Planning Approval Consistency Assessment Form

Sydney Metro – Metro Body of Knowledge (MBoK)

Assessment Name:	Revised temporary construction footprint for the Bradfield Station site
Prepared by:	Sydney Metro and PLM
Prepared for:	Sydney Metro / Stations, Systems, Trains, Operations and Maintenance (SSTOM) contractors
Assessment number:	SM002
Type of assessment:	Assessment under EP&A Act 1979, Division 5.1
Version:	Rev 9.0
Planning approval No. (where relevant):	SSI 10051 EPBC 2020/8687
Date required:	February 2025
iCentral number	SM-21-00431980

Figure 3: Revised Aerotropolis Core indicative construction site location shown by a black dashed line compared to approved project.

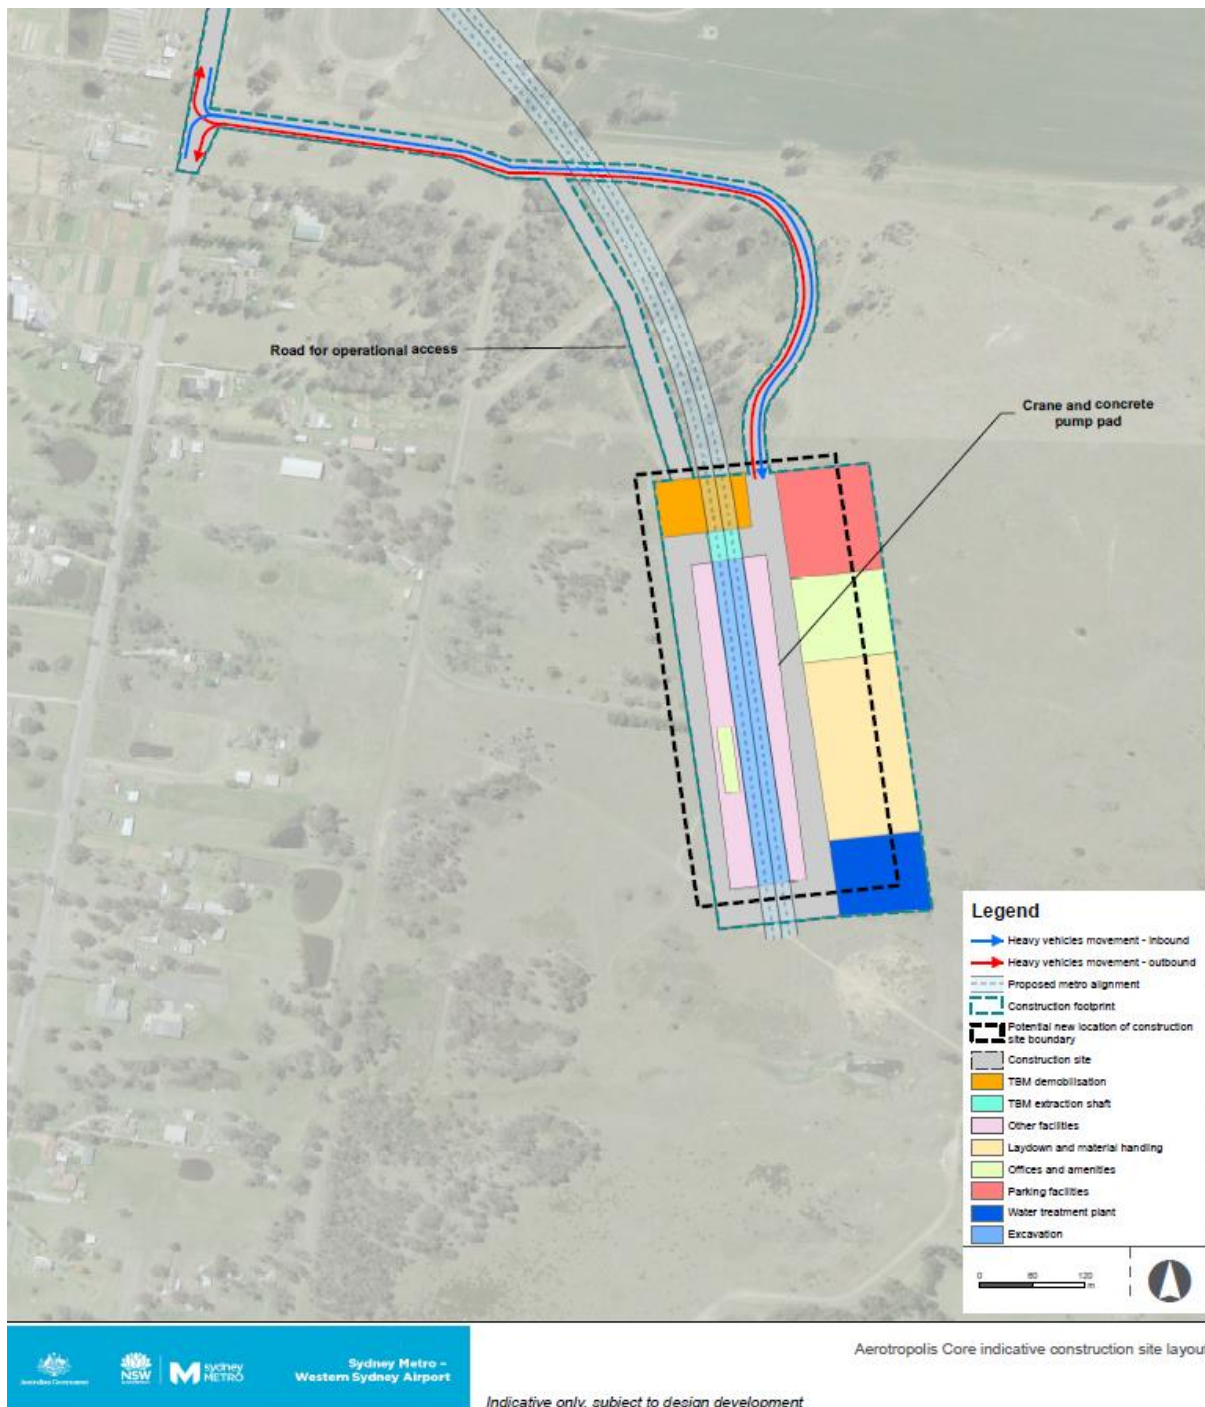
A previous version of this consistency assessment (Rev 8.0) to move the station site boundary up to 20 metres to the north and up to 20 metres to the west to accommodate a move of the station box within the site by approximately 75 metres to the north, was endorsed in February 2022. The revised location of the site is shown in Figure 3 of Appendix A.

Figure 4: Temporary construction boundary shown in yellow compared to approved project.

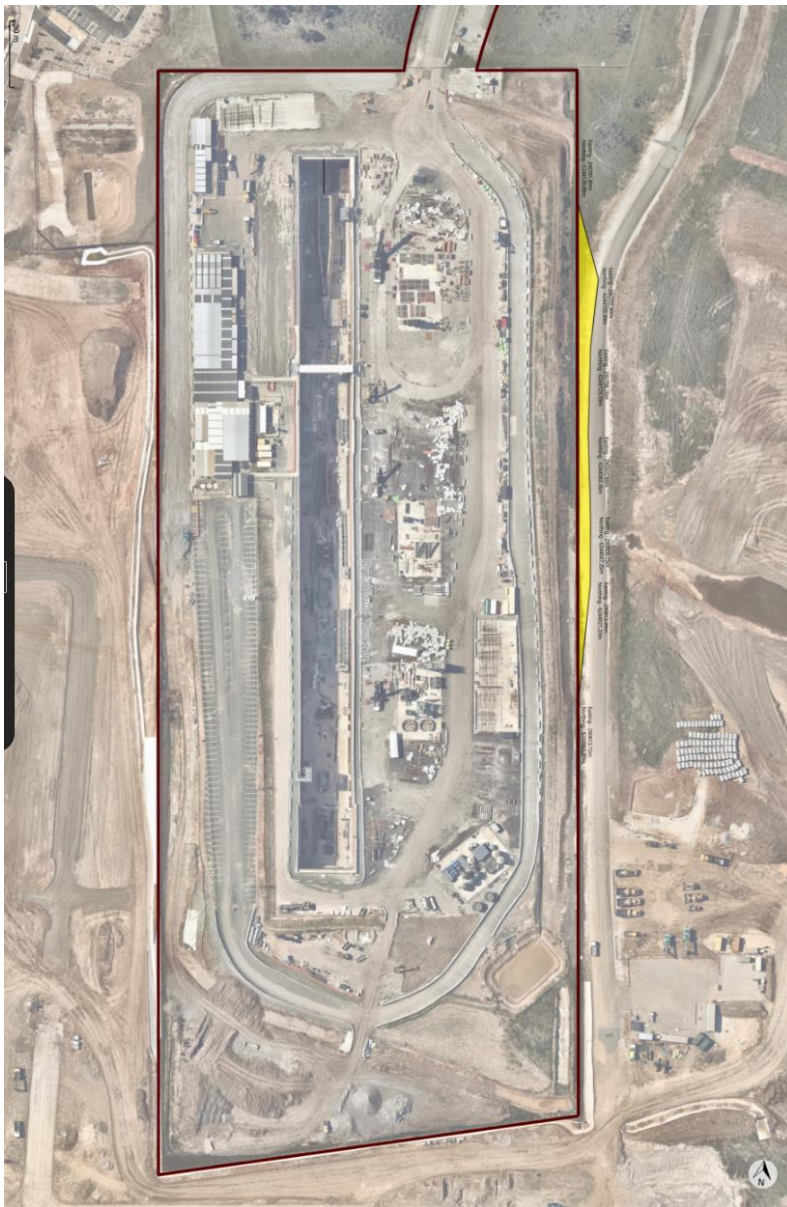
This updated consistency assessment makes further changes to the construction site which are needed for a temporary construction area to complete a portion of the batter along the eastern boundary of the site. The area is approximately 200m long and generally 5m wide. This area is currently being developed as part of the wider Bradfield City Centre construction as managed by the Bradfield Development Authority (BDA) (previously WPCA).

The proposed revised footprint for the Bradfield Station construction site is shown in Figure 4 and 5 of Appendix A.
